**REVISED\*<sup>1</sup> STAFF REPORT**  
**CITY OF LAKE OSWEGO**

**PLANNING DIVISION**

LU 13-0046

July 11, 2014

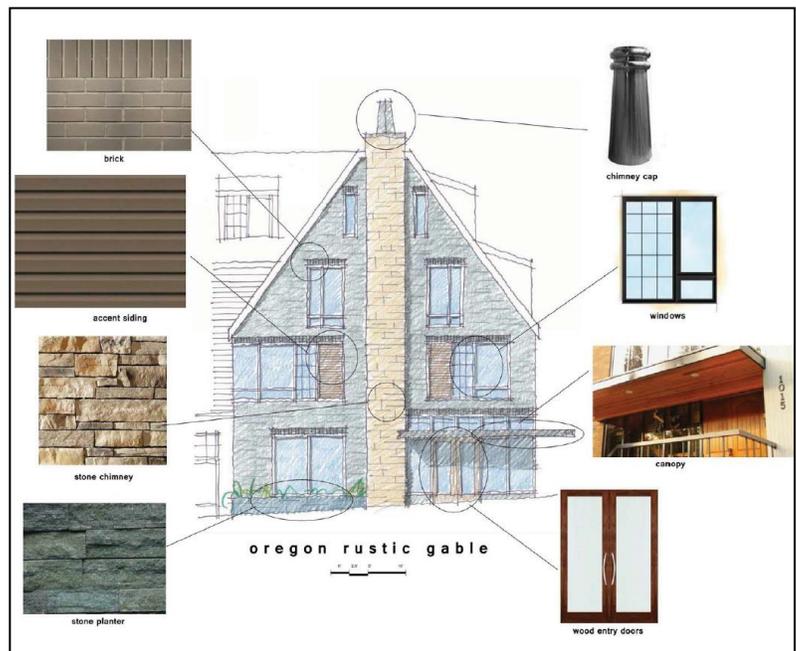
1<sup>st</sup> Street/Evergreen: This corner faces Millennium Park, and, because of the established roundabout, cannot provide a traditional 90 degree corner. The applicant has provided a significantly redesigned gable end facing the park, which complements the design at the roundabout corner of Lake View Village (LVV). This design incorporates a strong masonry base,

with an inset wood storefront, Tudor arch, and unique steel and glass canopy. Large light fixtures flank the entrance. Upper floors are lighter, with multiple windows and lighter-colored paneling. The fourth floor is located within the gable, and sits behind a wooden screen that adds depth and interest with shadow patterns; the residential unit is set back from the façade, similar to the LVV gable on the opposite corner. This standard is met.

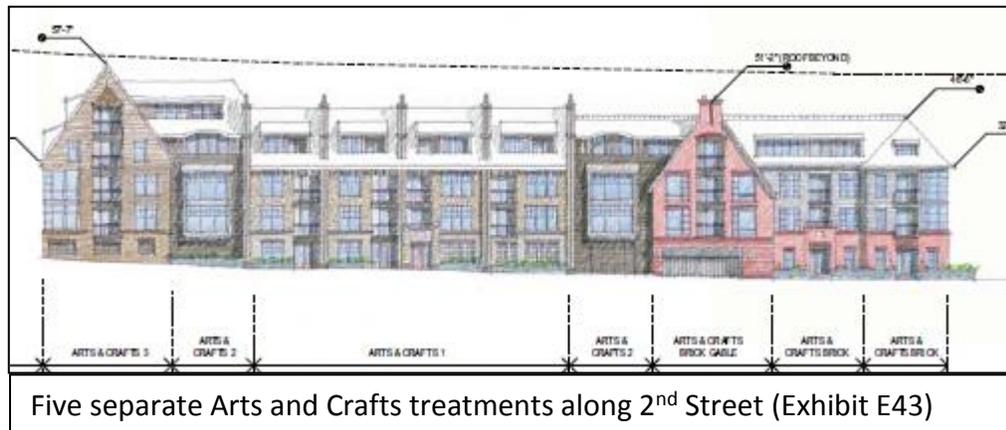
**Building A** is designed in modern Oregon Rustic style, with classic elements and materials rendered in a streamlined form. Of the three styles represented on the block, Oregon Rustic is the heaviest, with brick and stone as the predominant materials. Basalt is incorporated into the base of the building at the storefront and at the low wall that protects the specimen maple at the northeast corner. The three gables are bisected by wide chimneys, a prominent feature typical of many

Oregon Rustic structures. Lap siding is introduced on the upper levels, and the steeply sloped roofs are clad in a recycled composition material that has the appearance of slate tiles.

Five separate Arts and Crafts treatments along 2<sup>nd</sup> Street (Exhibit E43)

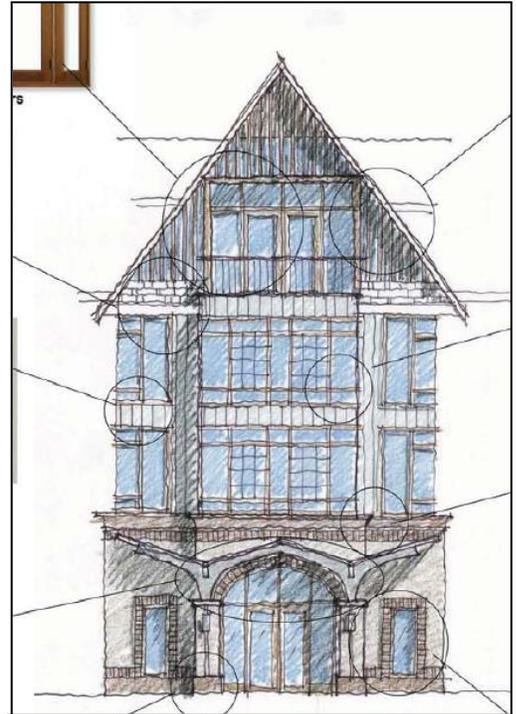
**Building B** is designed in modern Arts and Crafts style, with classic elements and materials. The building design includes intersecting pitched gable roofs, which create variety in height along the roof lines (Exhibit E43). The numerous, finely-patterned windows are typical of the style, as are the hipped gables and masonry and wood siding in combination. The proposed exposed roof rafter tails on the Arts and Crafts Segment 1 design element are also typical of the style, and further distinguish this segment from the other façade elements along the 2<sup>nd</sup> Street frontage. The exterior brick chimneys along the 2<sup>nd</sup> Street elevation, which extend to the ground and have a grooved seam, emphasize the residential character of the building. Building B is asymmetric, with five separate Arts and Crafts treatments along 2<sup>nd</sup> Street, and three separate treatments along Evergreen. Two distinct gable designs, one with a hipped gable and the other with a double chimney at the top of the gable, are found on each frontage.
